SHB5-BVD-RP-RP-CS-P3-001-Quality Audit

Stage 1 Quality Audit

(Incorporating a DMURS Street Design Audit, and Audits of Accessibility, Cycling, Walking and Road Safety)

Project Title	Proposed Housing Development at Basin View, Dublin
Project No.	24050-06
Client	Malone O'Regan
Document Title	Stage 1 Quality Audit
Document No.	24050-06-001

Figure 5.1 – Parking adjacent to priority crossing

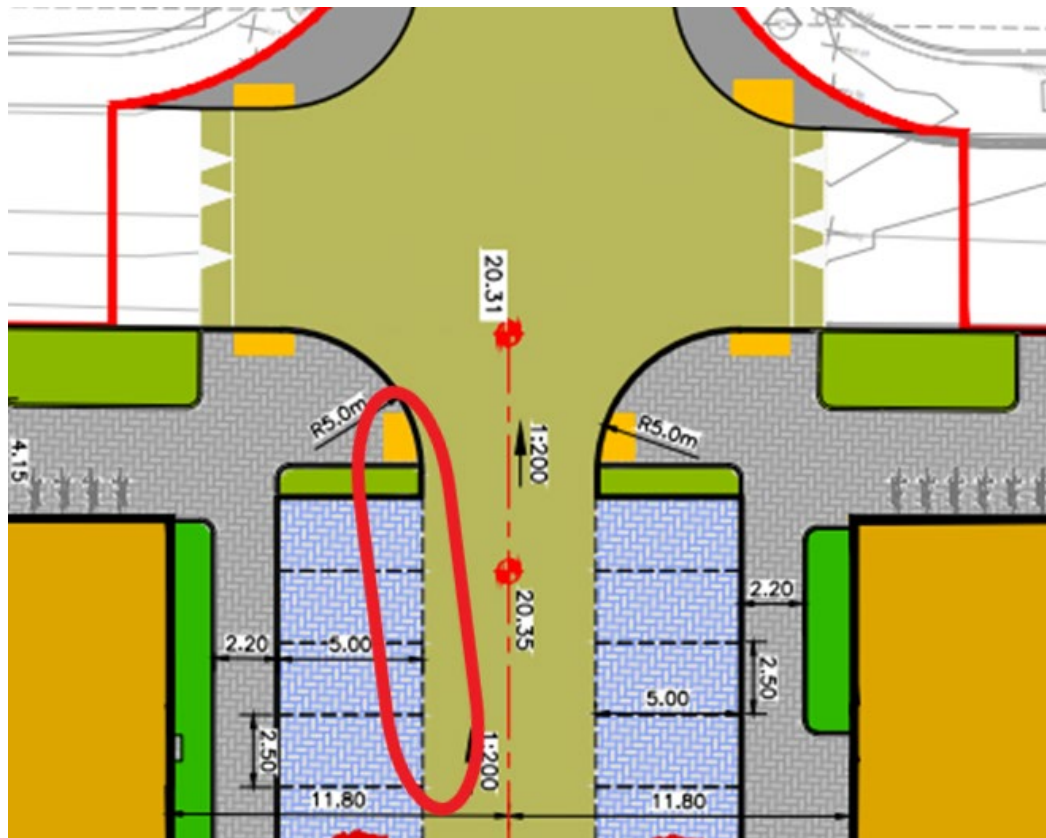
Intervisibility between drivers approaching the pedestrian crossing in Figure 5.1 and pedestrians at the crossing may be compromised by vehicles occupying formalised parking due to their proximity to the crossing. This may increase the likelihood of a collision at this location.

Rearrange the proposed parking layout and ensure intervisibility between motorist and pedestrians at all locations.

Figure 6.1 – Pedestrian connectivity

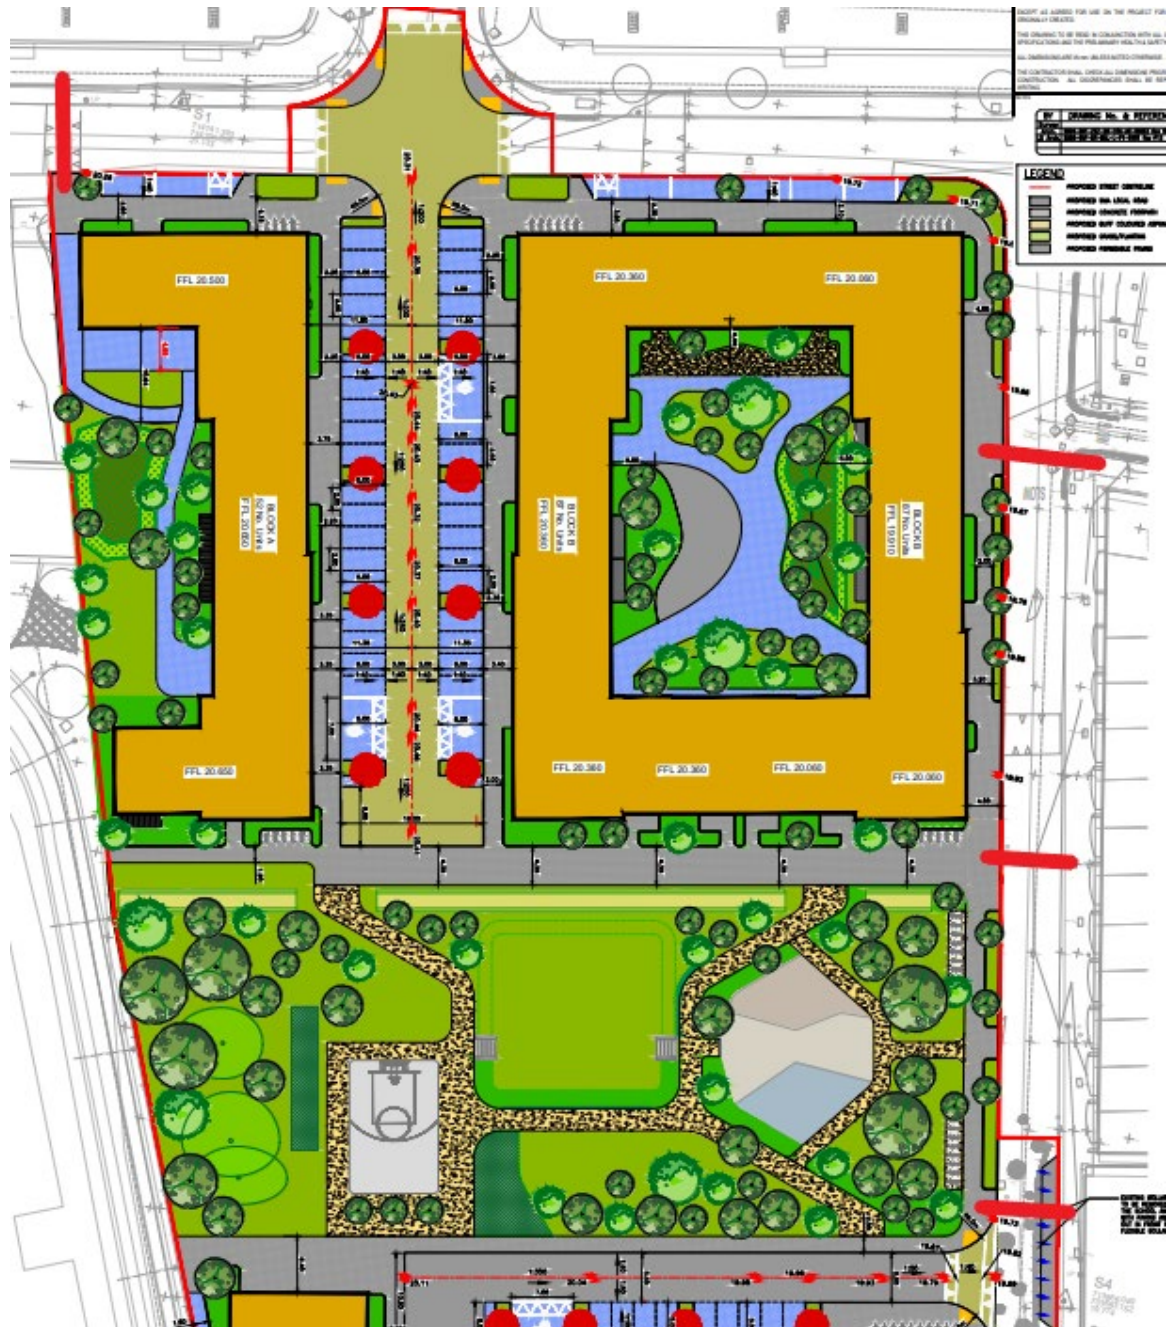
The existing footpath on the south side of Basin View to the northwest of the proposed development is discontinuous. There are also no pedestrian crossing facilities along Basin View long the front of the proposed development. It is unclear how pedestrians, exiting the proposed development will continue their journey west or east due to a lack of existing or proposed pedestrian facilities.

Provide adequate pedestrian facilities to ensure safe access to and from the proposed development along the pedestrian desire lines.

Figure 7.1 – GDA Cycle Network (www.nationaltransport.ie/wp-content/uploads/2023/01/2022-GDA-Cycle-Network.pdf)

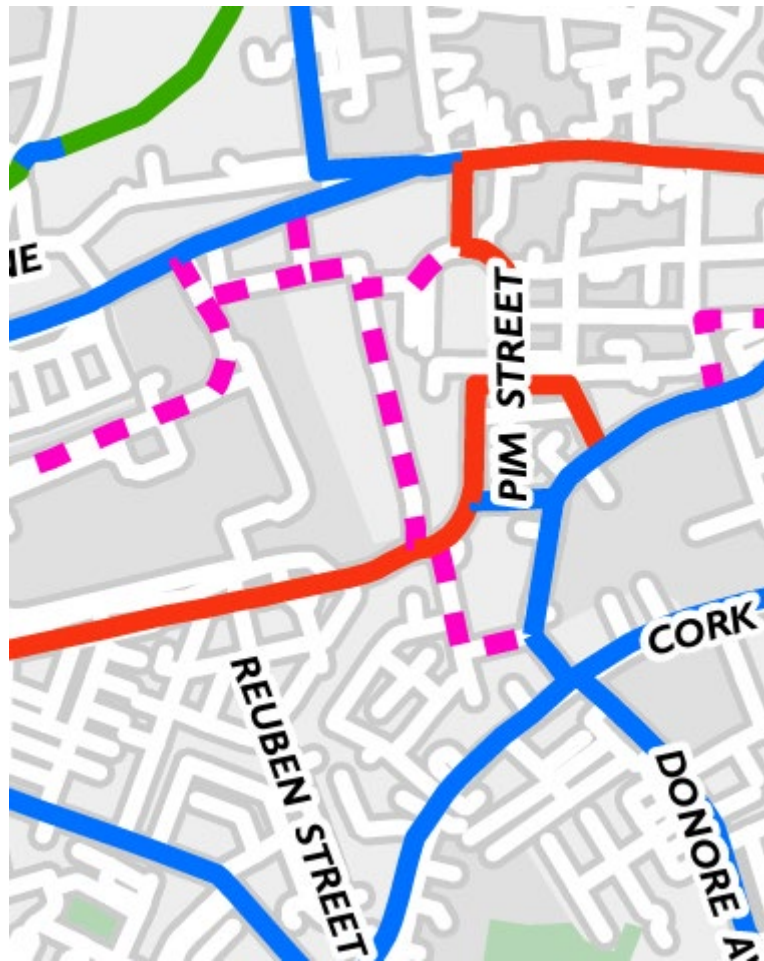
While there is no proposed cycle infrastructure in the development, it is not clear however how the development will tie into the proposed 'Primary Orbital' Cycle Route (red in Figure 7.4), the 'Secondary' Route (blue in Figure 7.4), or the 'Feeder' Route (dashed pink line in Figure 7.4). A lack of coordination may reduce the effectiveness of these schemes, proposed by Dublin City Council and National Transport Authority, and undermine potential to achieve cyclist desire lines.

Consider wider network impacts of future schemes to support a network of segregated cycleways through the development. Consult with Dublin City Council Active Travel to ensure the development is futureproofed.

Figure 8.1 – Disabled Bay

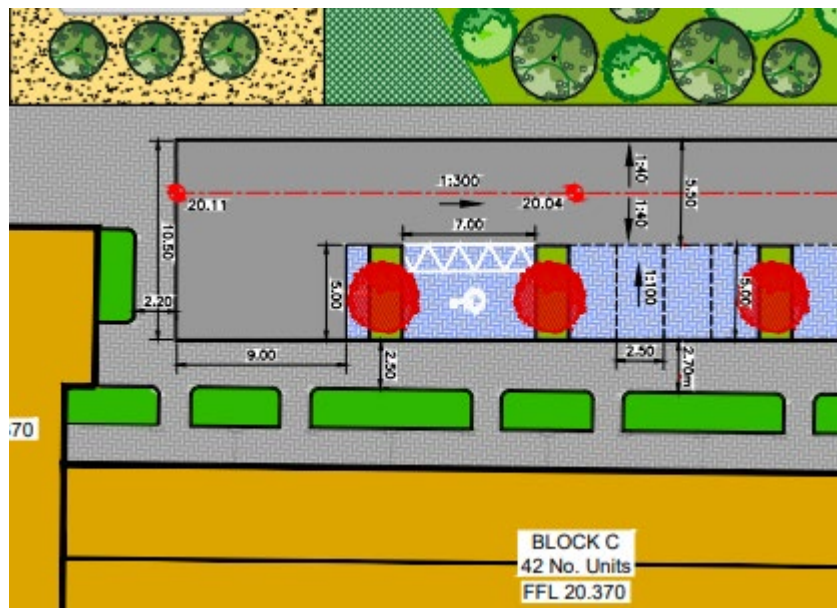
The proposed disabled bays (Figure 8.1 and 8.2) are arranged parallel to the footway. There is no ramped access to the footway and users may have to enter/exit their vehicles from the vehicular carriageway.

Ramped access should be provided to all disabled parking bays.
